Re: 13CVCP086K
235-263 North 9th Street, Brooklyn, NY
Remedial Action Work Plan (RAWP) Stipulation List

Environmental Business Consultants hereby submits a Remedial Action Work Plan (RAWP) Stipulation List for the Site to the New York City Office of Environmental Remediation (OER) on behalf of Fortis Property Group. This letter serves as an addendum to the RAWP to stipulate additional content, requirements, and procedures that will be followed during the site remediation. The contents of this list are added to the RAWP and will supersede the content in the RAWP where there is a conflict in purpose or intent. The additional requirements/procedures include the following Stipulation List below:

235-245 & 261-263 N. 9TH STREET
 BROOKLYN, NY
FIGURE 8
ENDPOINT SAMPLE LOCATIONS

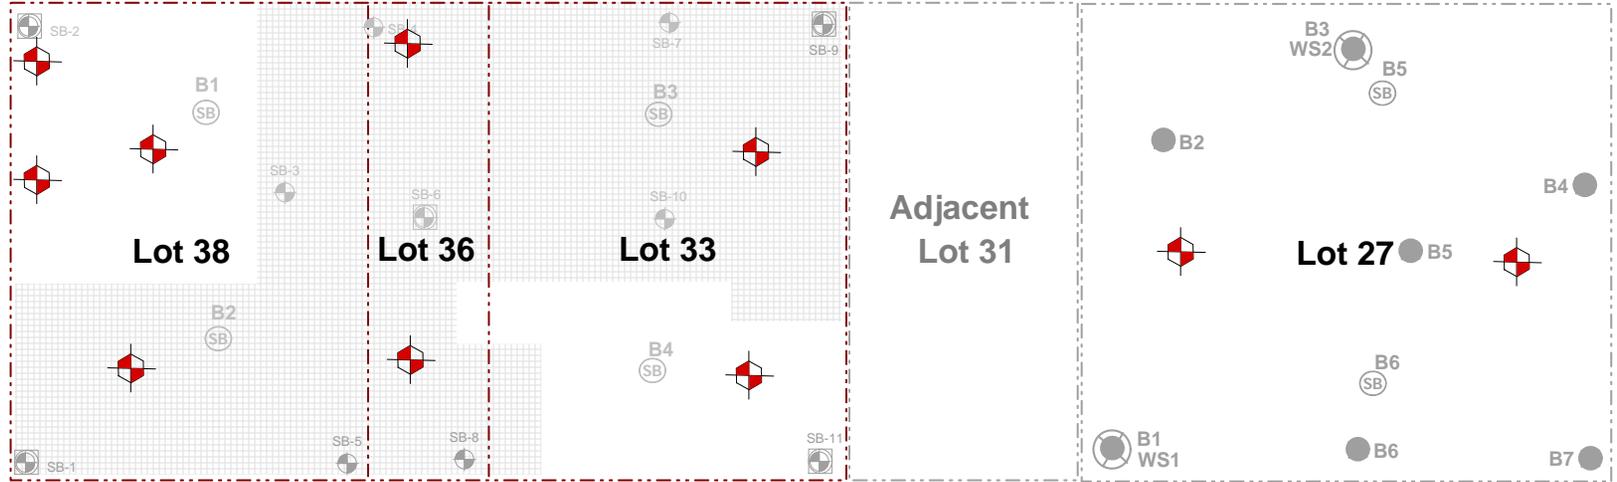
7. Collection and analysis of endpoint samples (Section 4.2) will be conducted to evaluate the performance of the remedy with respect to attainment of Track 4 SCOs. A map indicating post-remedial endpoint sampling locations is provided in **Addendum 3**. End point sampling locations considers both known metal hotspot areas and general area-wide sampling. The hot spots include a petroleum hot spot in northwest corner of Lot 38 (Project A), a metals hotspot identified in the rear of Lot 36 within soil sample B4(2-6) in 2008 and the metals hotspot identified in 2006 on the east side of Lot 27 - Project B within soil sample B4-S3 (8-12').

SSDS SYSTEM LAYOUT

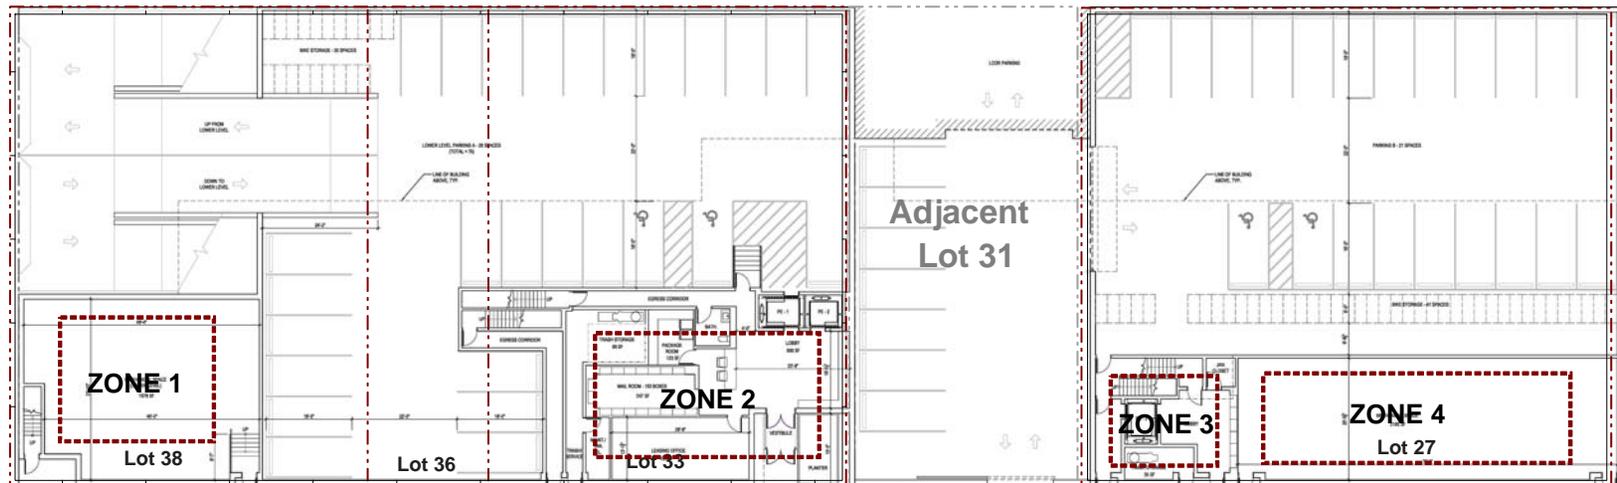
9. A sub-slab depressurization system (SSDS) is specified for the occupied slab-on-grade portions of the building. Parking areas in the below-grade area of Project A and the first floor on Project B will have high volume air exchange per DOB mechanical code. Installation and operation of an active SSDS beneath the lobby and any other non-parking base level areas in each building (mechanical rooms, storage, etc.). **Addendum 4** is a diagram of the active SSDS layout and identifies the vent pipe(s) location.
